Houston Lighting & Power P.O. Box 1700 Houston, Texas 77001 (713) 228-9211

October 24, 1985
ST-HL-AE-1460
File No.: G9.17

South Texas Project
Units 1 and 2
Docket Nos. STN 50-498, STN 50-499
Loss of FW Transient; Decay Heat Curves

Attachment: Revised FSAR Chapters 10 and 15

No. 100 of Normal Feedwater
Figure 15.2.9A

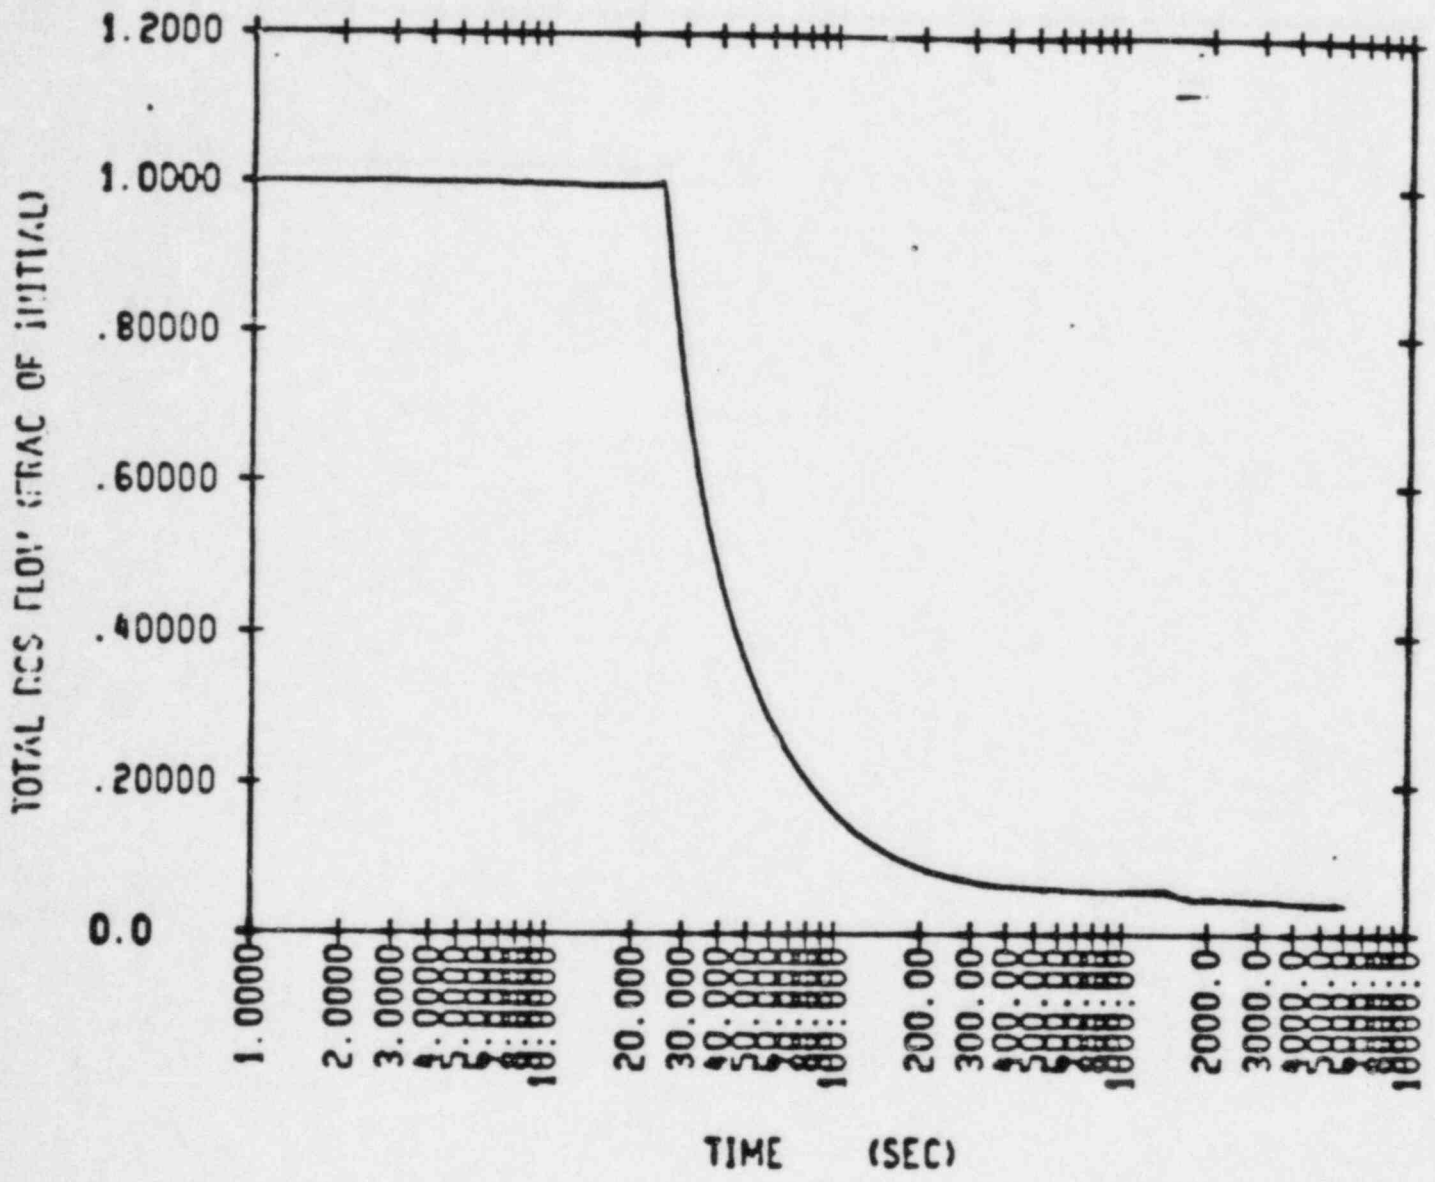
15.2-9A through 15.2-9D

15.2-9A
through
15.2-9D

*Replace with the next
5 sheets.*

Figure 15.2.4 D

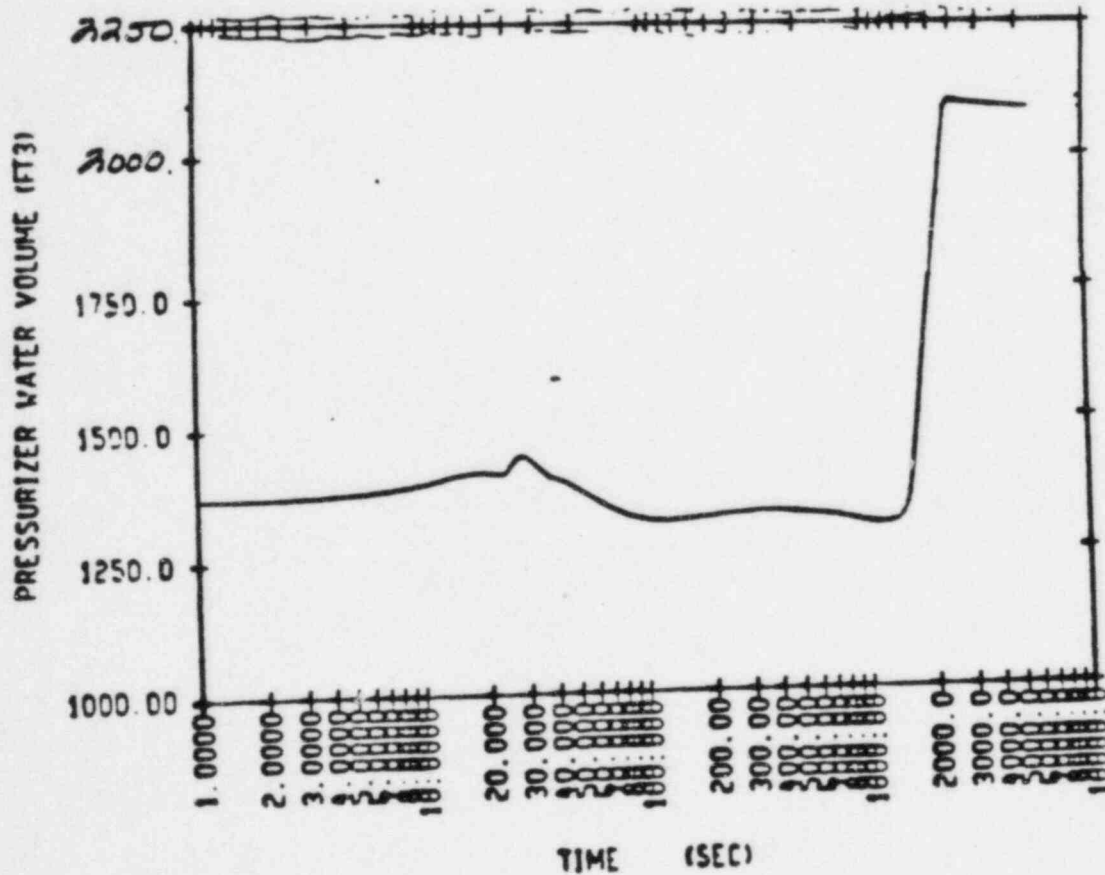
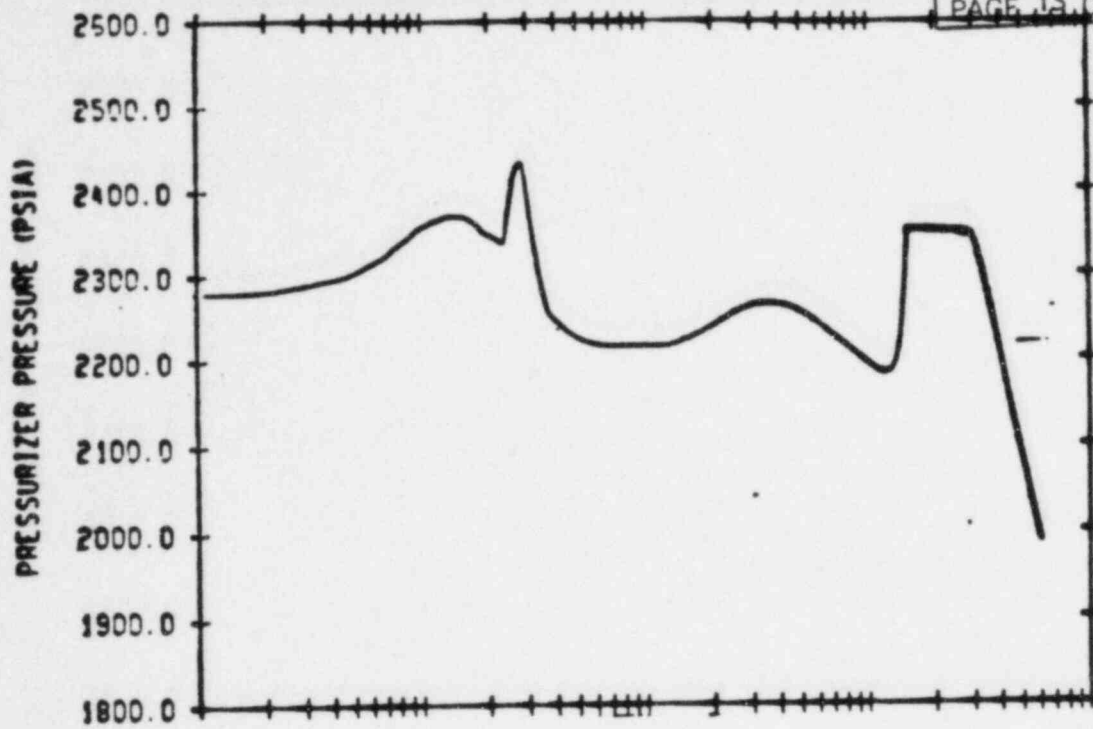
The analysis also indicates that at no time is there water relief from the pressurizer; Figure 15.2-9D shows that the peak water volume in the pressurizer is less than 2100 ft^3 which is the filled pressurizer volume.

Figure 15.2-10

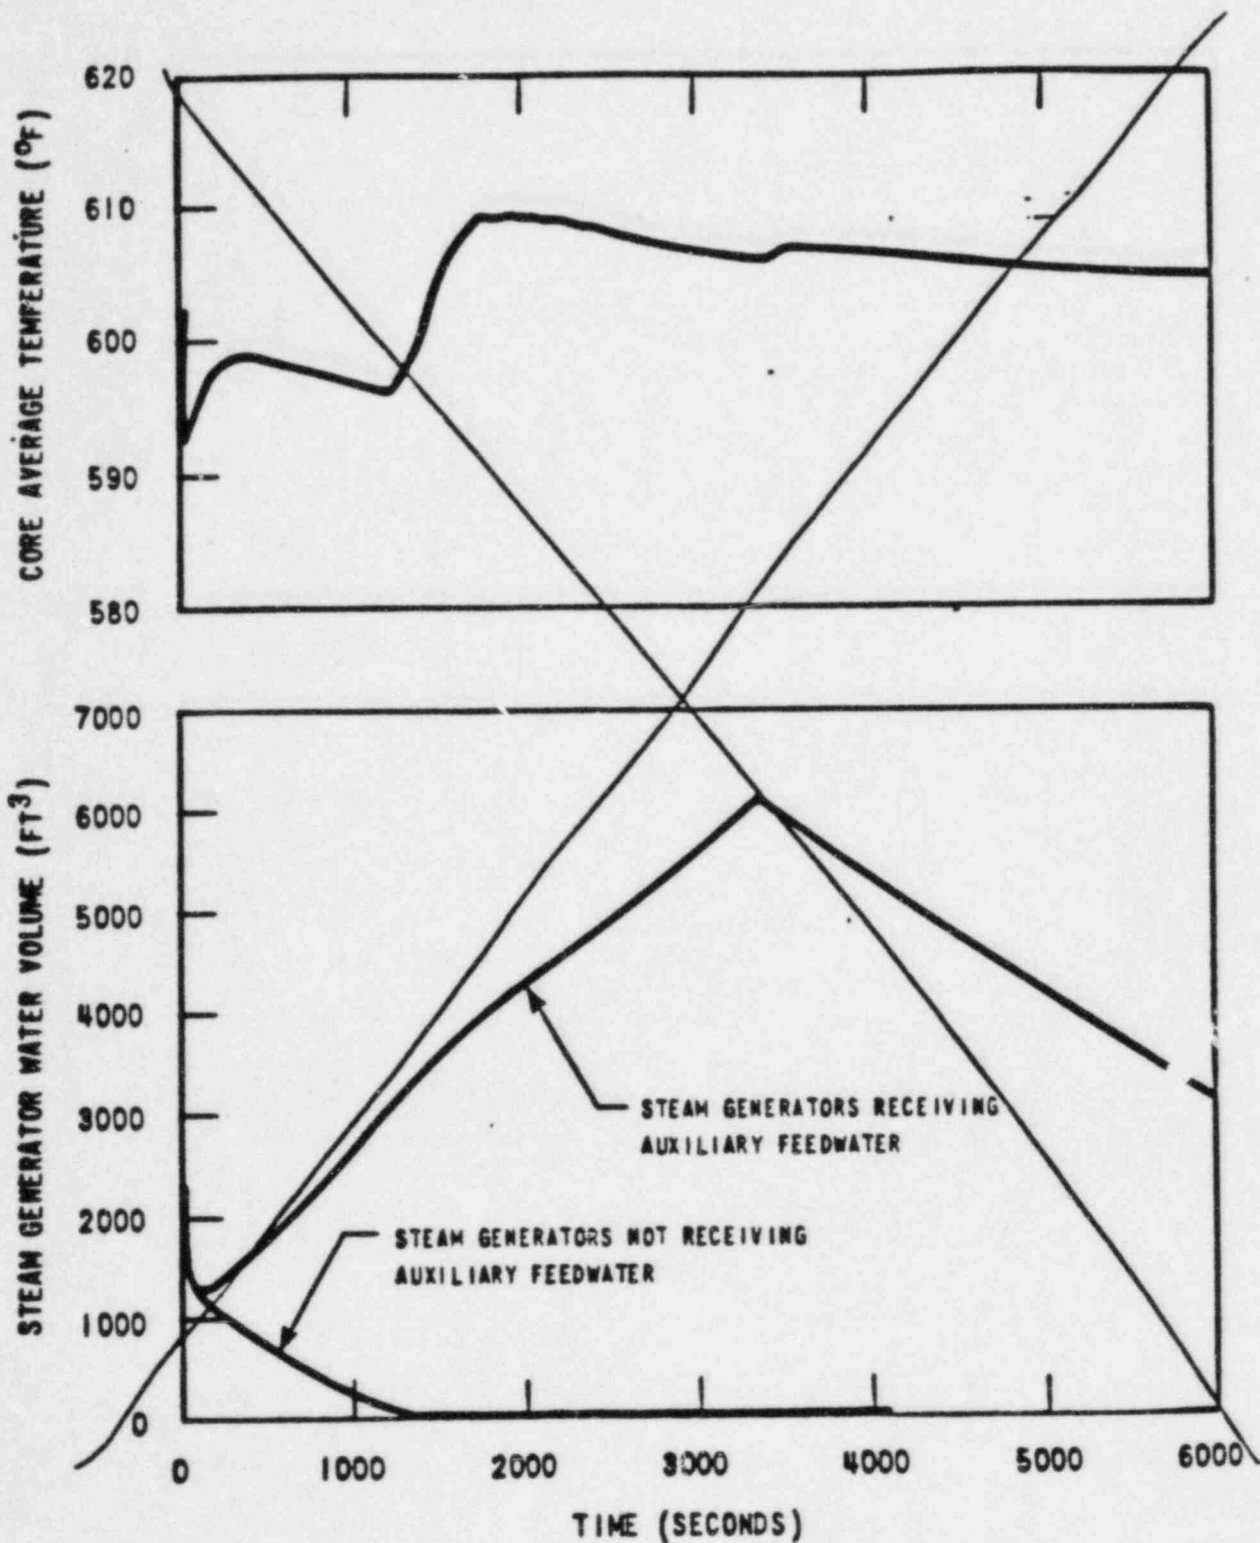
Delete
